COAL MINING AND RECLAMATION PERMIT APPLICATION TO REVISE A PERMIT (ARP)

Permit Number: D-1159
Application Number R-1159-10

Revise location of PFL soil piles

APPLICATION TO REVISE A COAL MINING PERMIT

AMERICAN ENERGY CORPORATION
CENTURY MINE (PERMIT D-1159)

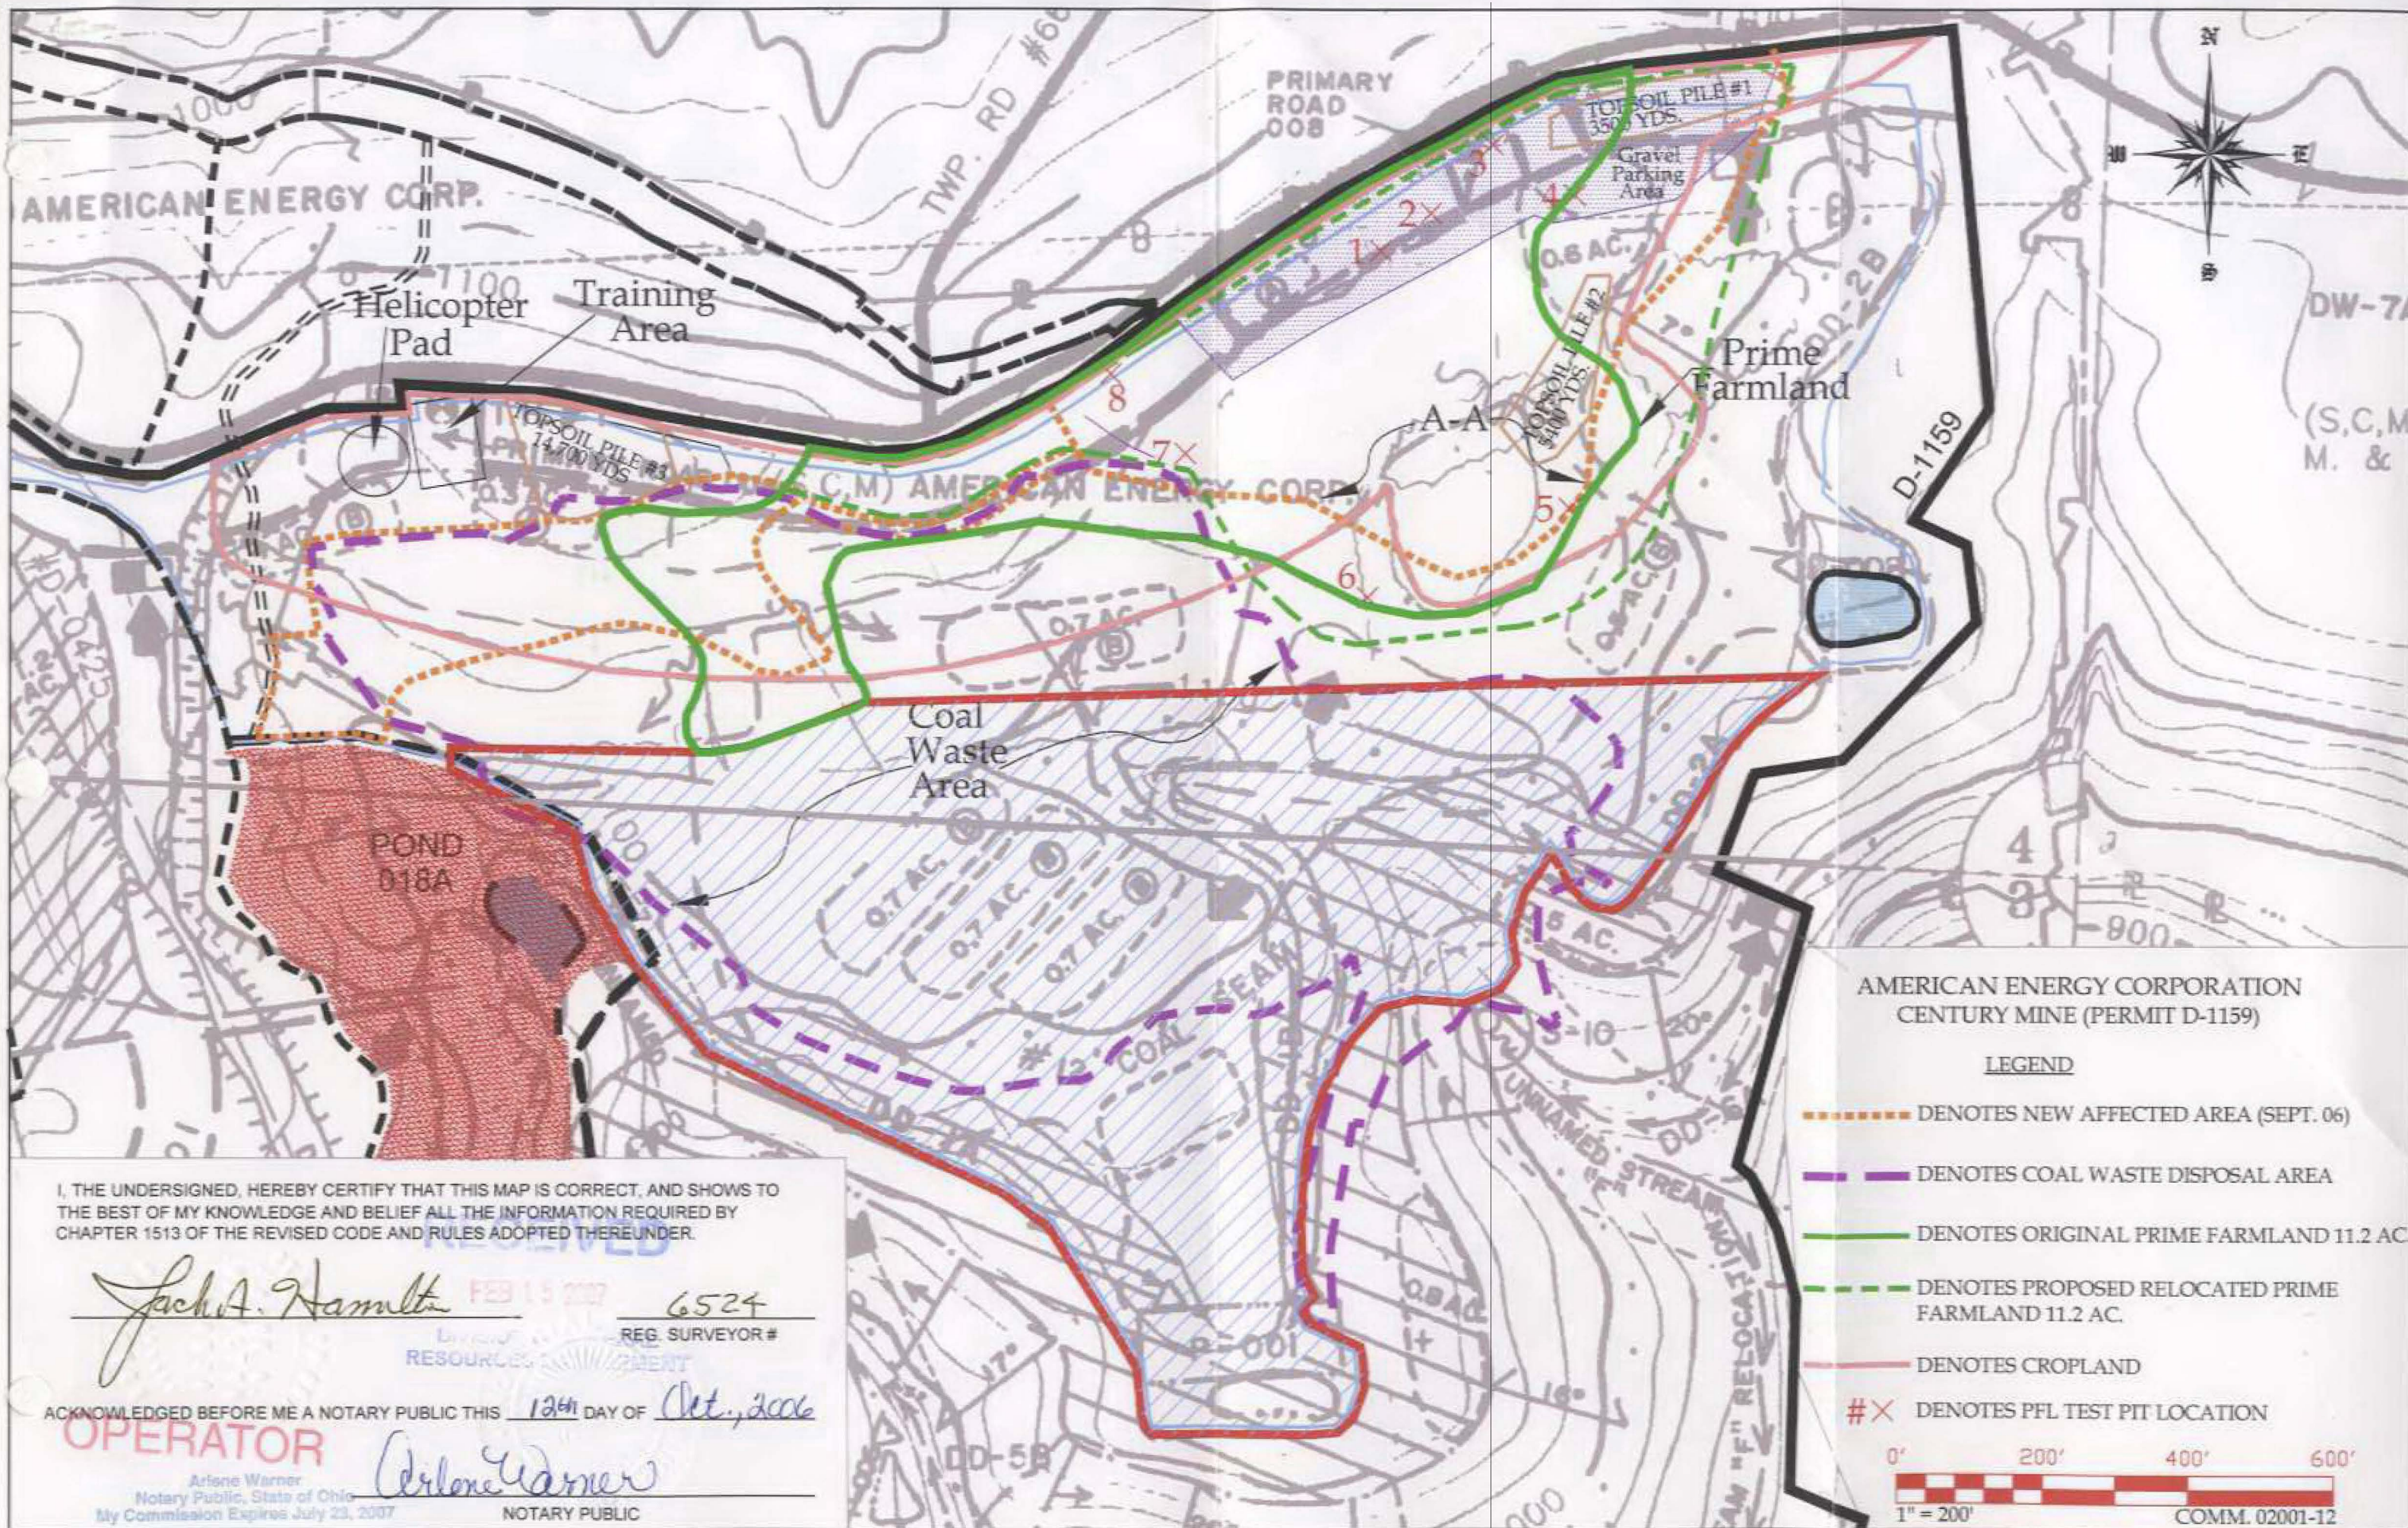
This proposed revision is a request to relocate the prime farmland area. See attached letter dated October 12, 2006 and accompanying information and map.

Coal waste was deposited on a portion of the prime farmland area mandating that it be relocated to provide the same acreage post-mining that existed pre-mining.

6. The PFL area will be relocated and reconstructed in the approximate location shown on the attached map when it is determined that all mining activities are completed in this area.

AMERICAN ENERGY CORPORATION
 CENTURY MINE (PERMIT D-1159)

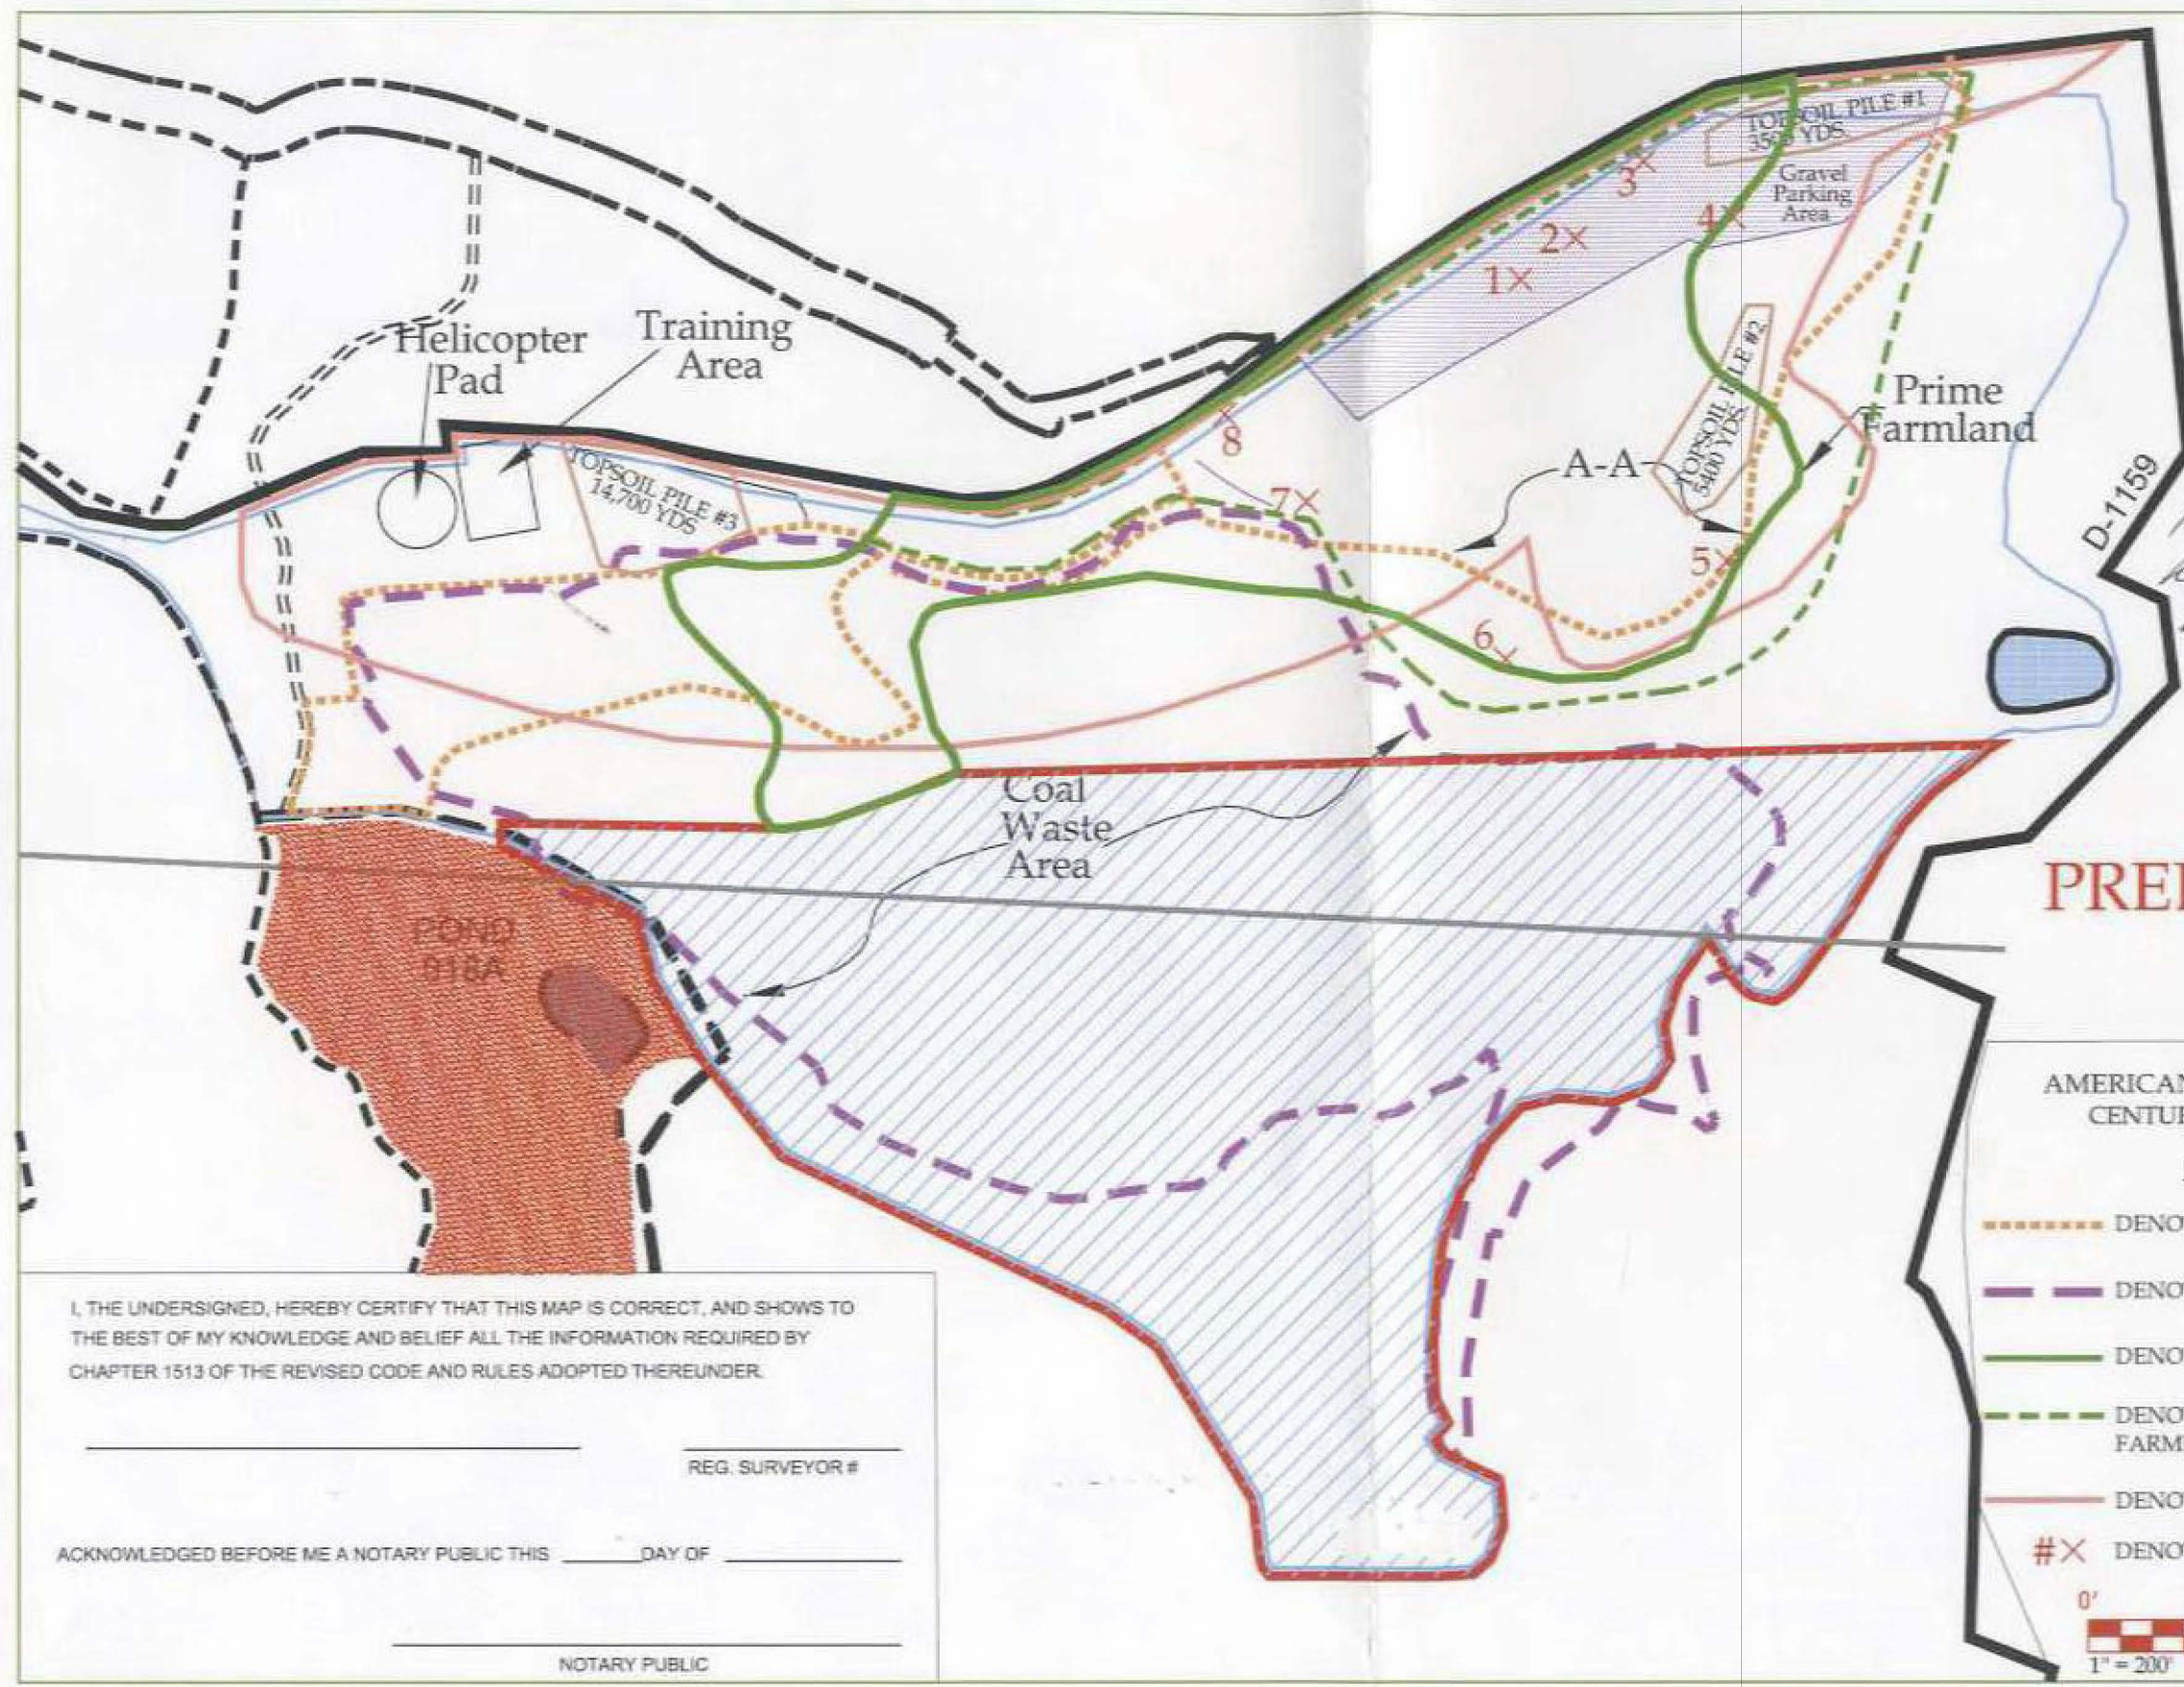
10/11/06
 This map is be revised
 by Stck. I will get the
 revised Dwg. He will email
 back my copy.

SOIL RECONSTRUCTION

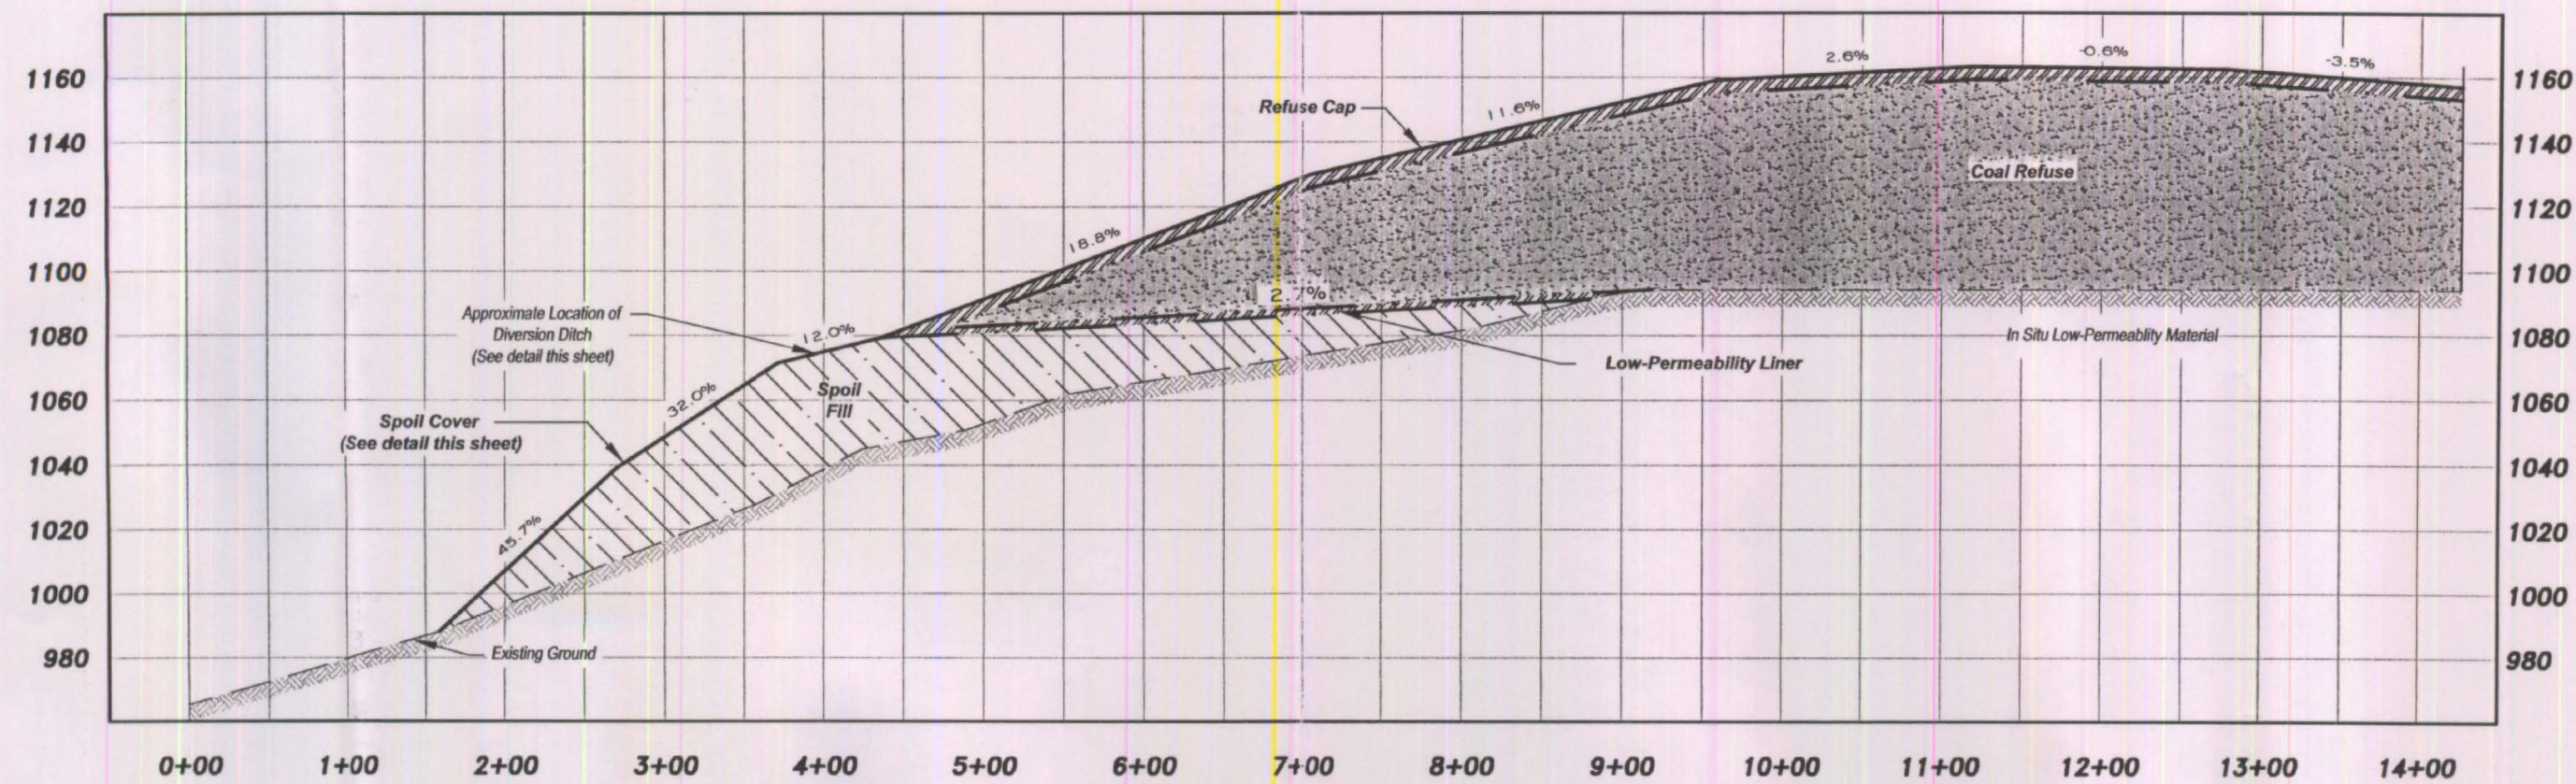
THIS PROPOSED REVISION IS TO CHANGE THE THICKNESS OF "A" HORIZON MATERIAL TO BE REPLACED FROM 12 (TWELVE) INCHES TO 7 (SEVEN) INCHES. SEE ATTACHED ADDENDUM TO ATTACHMENT 15, ITEM 1 AND ADDENDUM TO ATTACHMENT 15, ITEM 4 OF THE ORIGINAL PERMIT.

THE TWELVE INCHES SPECIFIED IN THE APPROVED PERMIT IS IN ERROR. THE WhB SOIL IS LISTED AS ABOUT 7 INCHES THICK ON THE NRCS REPORTS CONTAINED IN THE PERMIT AND OBVIOUSLY 12 INCHES CANNOT BE REPLACED WHEN THERE WAS ONLY 7 ORIGINALLY.

THE MATERIAL FROM THE "A" HORIZON WILL BE REPLACED ON TOP THE "B" AT A UNIFORM THICKNESS NOT LESS THAN **SEVEN** INCHES. THIS THICKNESS RESTORATION, COMBINED WITH THE INSTALLATION OF PROPER ARTIFICIAL DRAINAGE, FERTILIZER AND LIME APPLICATION AS DETERMINED BY LABORATORY ANALYSIS AND PROPER MANAGEMENT PRACTICES WILL CREATE A FINAL SOIL HAVING AN EQUAL OR GREATER PRODUCTIVE CAPACITY THAN EXISTED IN THE SOIL BEFORE MINING .
